Final Safety Evaluation Report

Related to Certification of the
AP1000 Standard Design

Volume 3

U.S. Nuclear Regulatory Commission
Office of Nuclear Reactor Regulation

Figure 21.A-15
CCTF Run 58, Loop 1 Cold Leg Steam Mass Flow Comparison

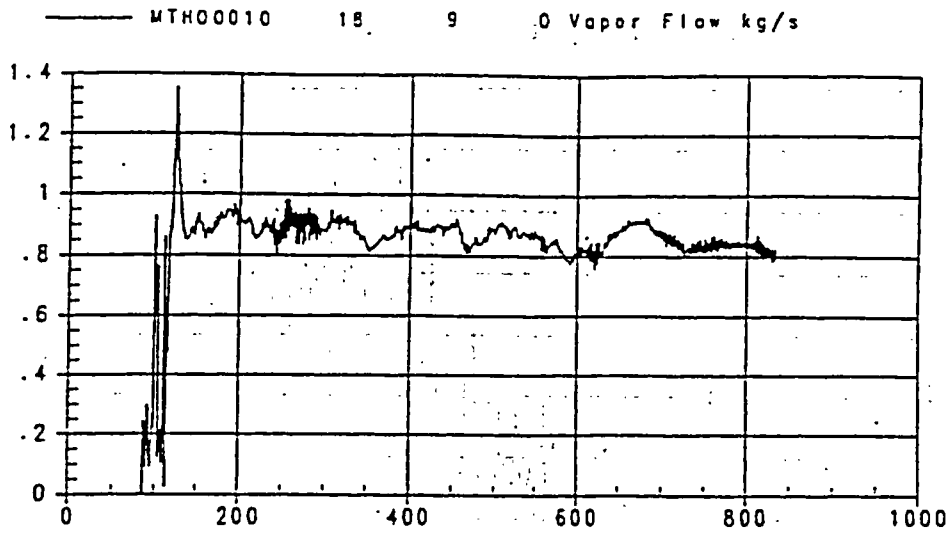
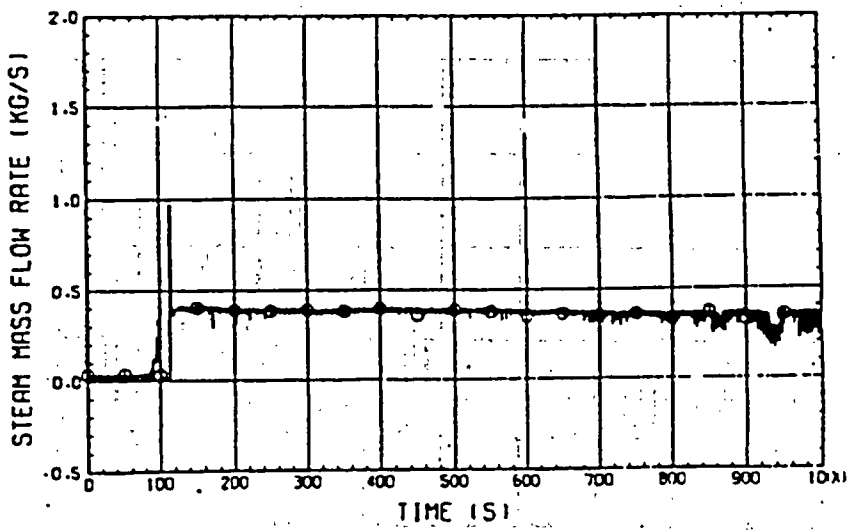
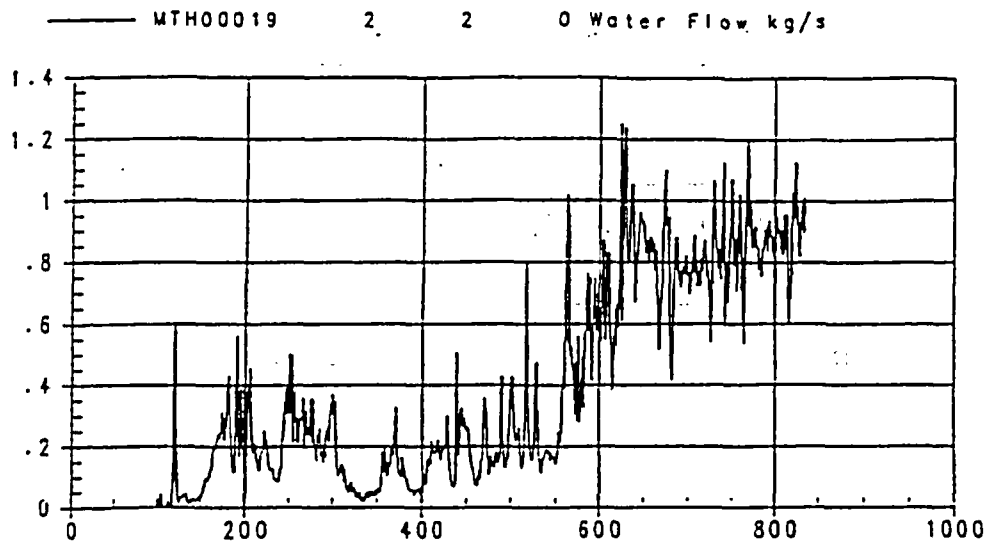
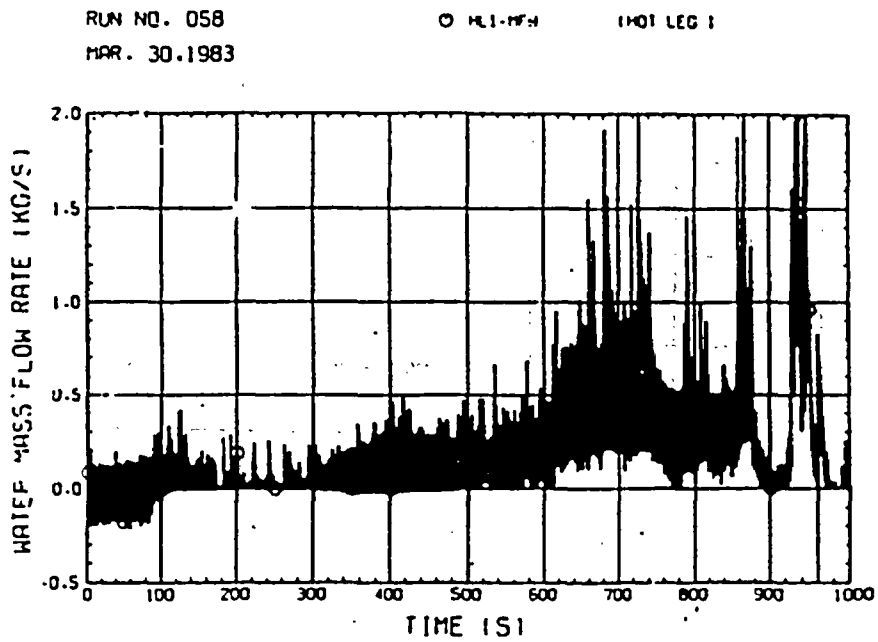
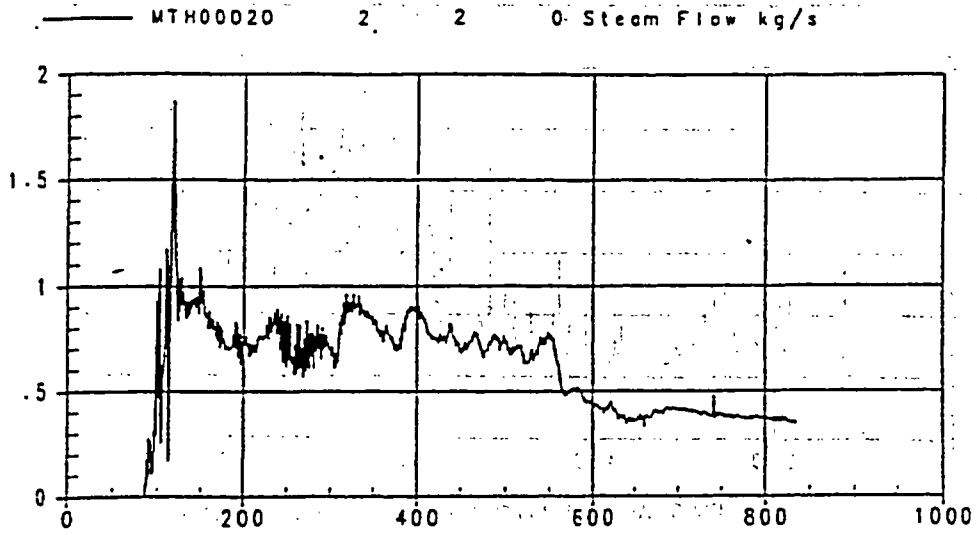
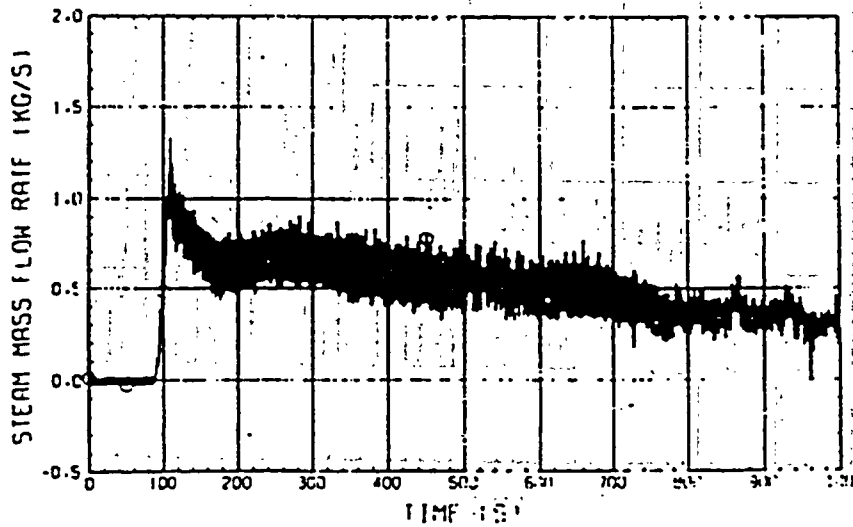
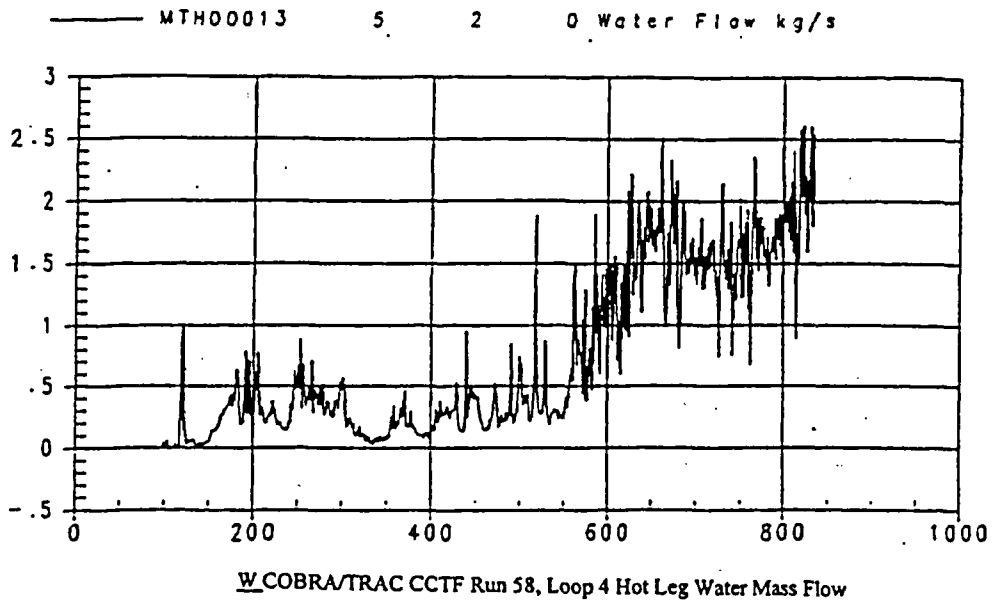
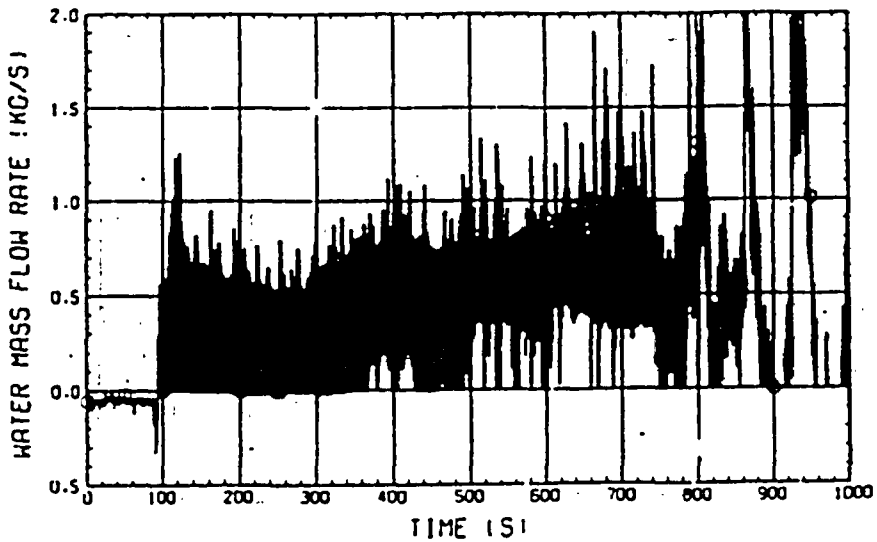
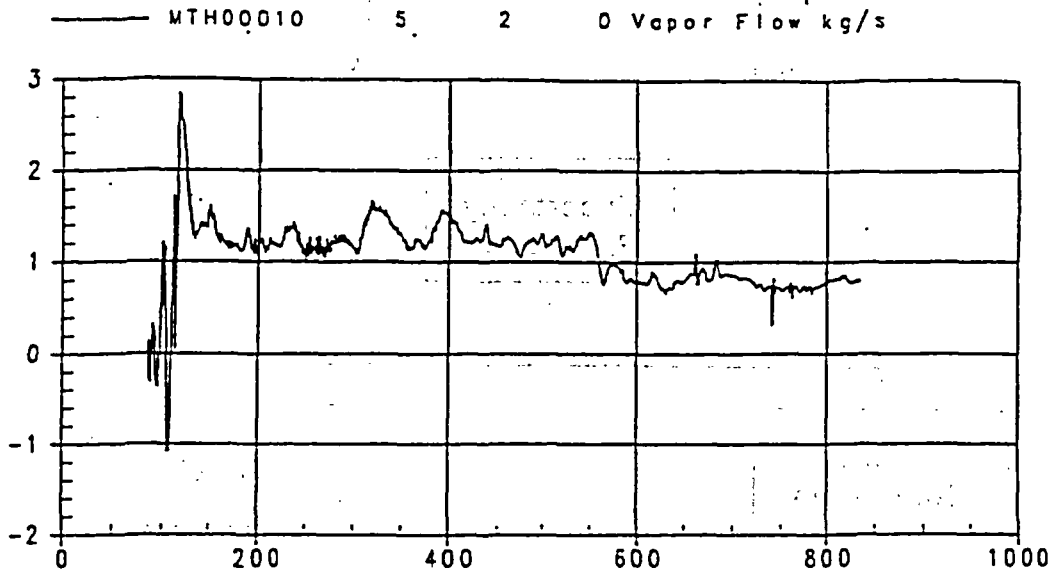
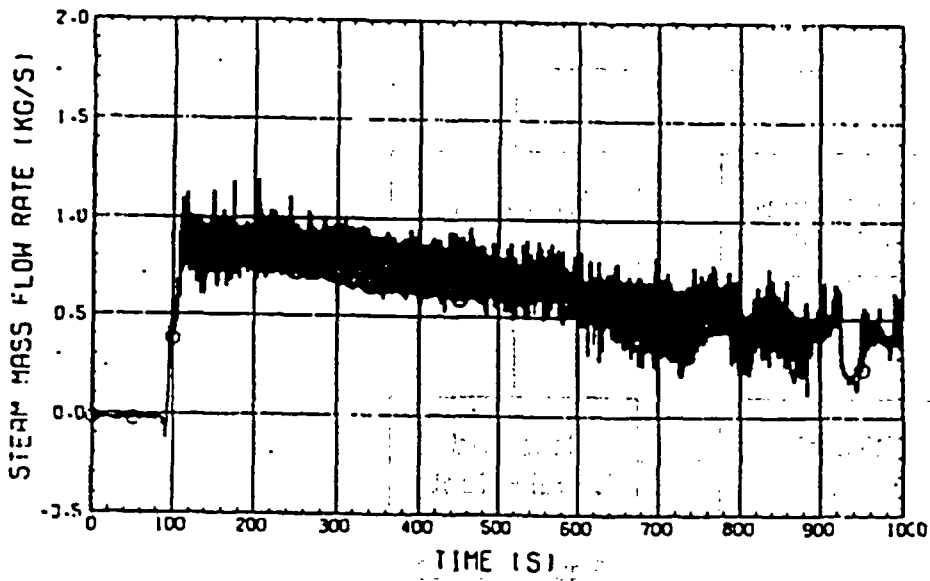
The upper plenum pressure was overpredicted for most of the test (Figure 21.A-12 of this report) because the more rapid quench advancement in the calculation resulted in higher steam production relative to the test. Downcomer and core differential pressure comparisons (Figures 21.A-13 and 21.A-14 of this report, respectively) showed that the calculated downcomer pressure difference was within the band of the oscillations observed in the test, and the measured core pressure difference was well predicted. Regarding loop flows, the comparisons showed that, in general, WCOBRA/TRAC results were relatively close to the test data except for the Cold Leg 1 and Hot Leg 4 steam mass flows, which were overpredicted (Figures 21.A-15 to 21.A-19 of this report).

Figure 21.A-20
Breakdown of Westinghouse's Uncertainty Parameters

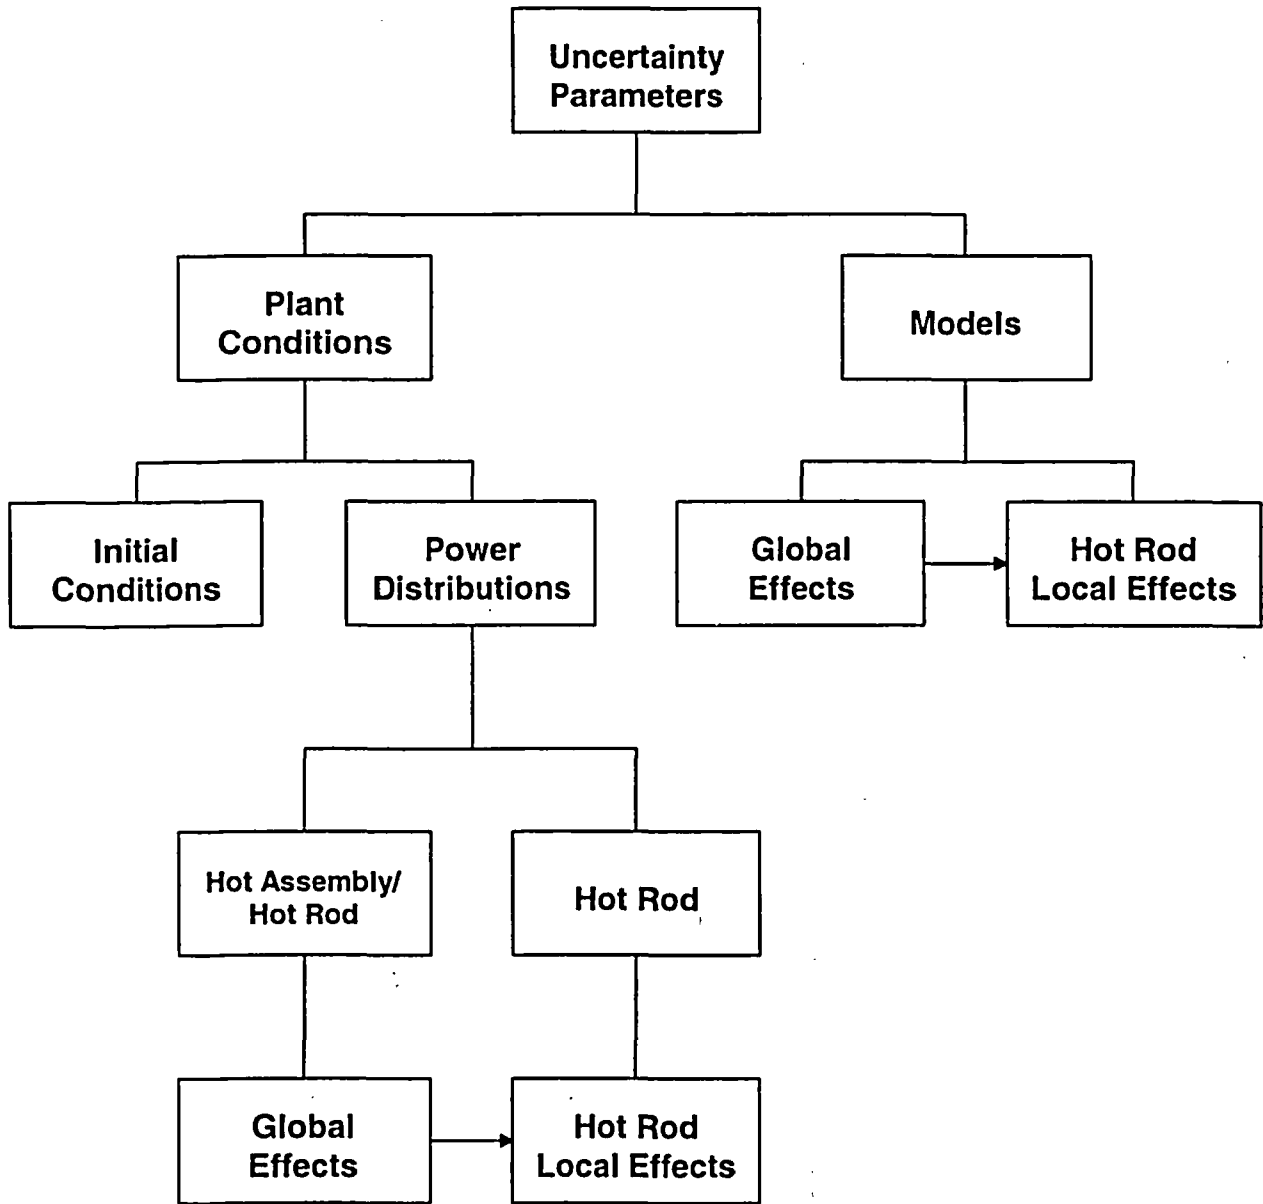
In the approved uncertainty evaluation, the applicant identified initial plant conditions and model effects as the important factors to consider. The plant conditions were further subdivided into initial conditions and core power distributions. In addition, a model or plant condition may be global or local in its effect. A parameter has a global effect if it can affect the entire thermal and hydraulic transient. It has a local effect if it only affects the local conditions at the PCT location. The interrelationship of the uncertainty parameters is shown in Figure 21.A-20 of this report.
